UNITED STATES PATENT AND TRADEMARK OFFICE

10/572,322

Christian Bastein

Office Action Summary	Application No. 10/572,322	Applicant(s) BASTEIN ET AL.	
	Examiner Thomas Diaz	Art Unit 4171

Below are images of the applicant's disclosed apparatus:

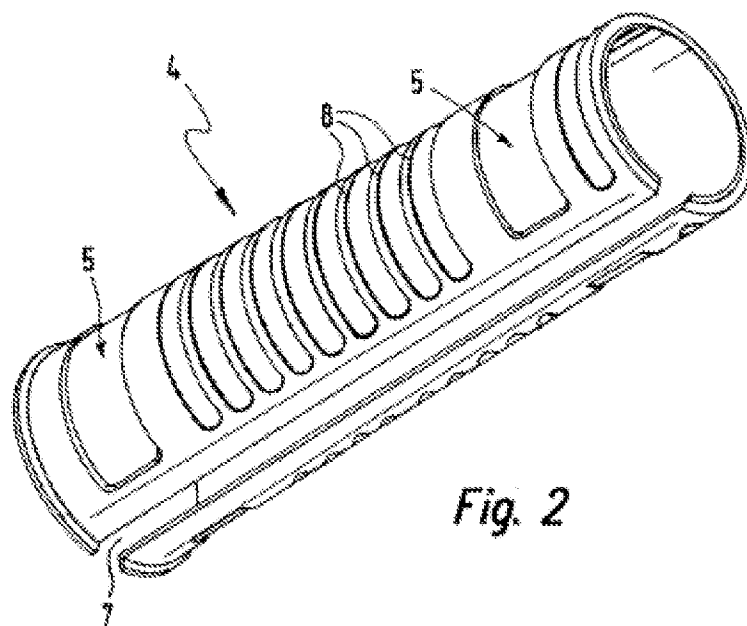
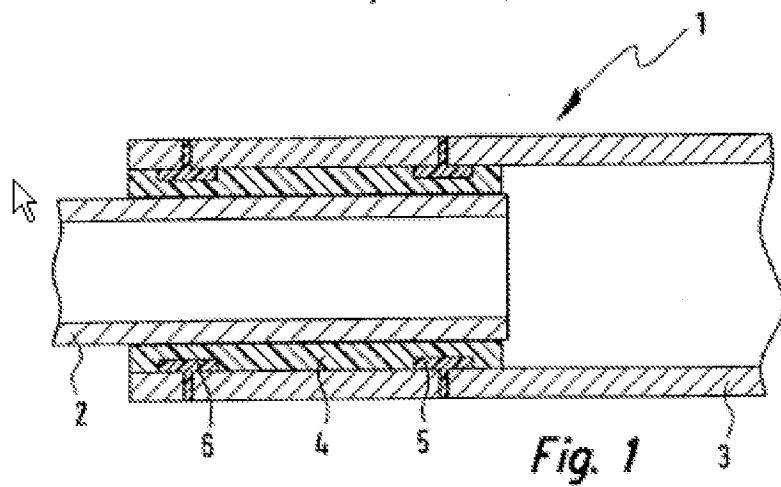
- an inner steering column element (fig. 3, Part #28) which accommodates a steering spindle (fig. 2, Part #18) corresponding to applicant's Item# 2 (see figures below),

- an outer steering column element (fig.3, Part #30) which is arranged radially around the inner element corresponding to applicant's item# 3,
- a sliding bush (fig.5, Part #56) corresponding to applicant's item# 4, which is connected to the outer element and which allows the inner and outer elements to be displaced with respect to one another,

- a pocketlike depression (fig.5, Part #66) corresponding to applicant's item# 5, which runs radially around the outer surface of the bush and when in the mounted state is filled with plastic by injection molding (col. 3, lines 19-21) through the opening (fig. 3, Part #86) provided in the outer element and forms a fixed connection between the outer element and the sliding bush as depicted in figure 3; the pocketlike depression extending to the axial ends of the sliding bush,

- reinforcing ribs (fig. 5, Part # 74a, 74b) for the purpose of providing structural support to the bushing corresponding to applicant's item# 8,
- the sliding bush under a prestress as explained in col. 2, lines 60-63 and col. 3, lines 3-40. The sliding bush is squeezed before being placed inside the outer element thus being prestressed in order to withstand the stresses or loads created during injection molding process and still maintain a low friction connection between the inner and outer elements.

Regarding claim 6, Burkhard et al. teaches a sliding bush with a slot extending longitudinally (fig. 5, between 68A and 68B) corresponding to applicant's item# 7,

FIG. 4

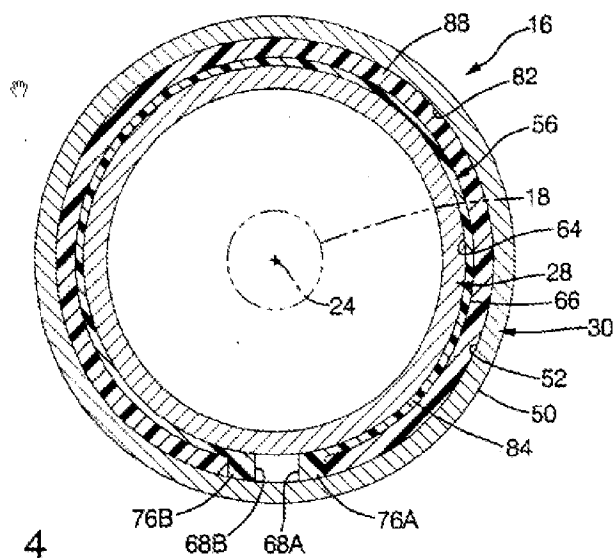
Regarding claim 8,10, and 11, Burkhard et al. teaches an inner steering column element, outer steering column element, and sliding bush which are cylindrical in shape as depicted in figure 4.

FIG. 5

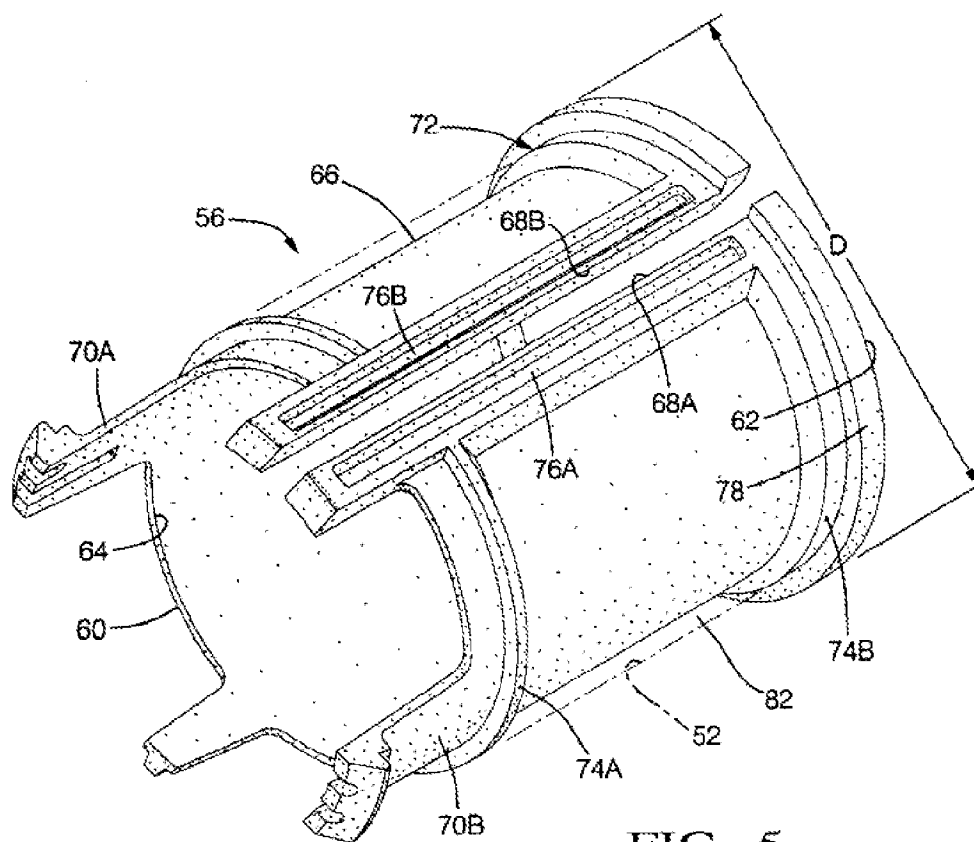
Burkhard et al. fails to teach a plurality of pocketlike depressions and also fails to specifically teach the location of the reinforcing ribs being between the depressions.
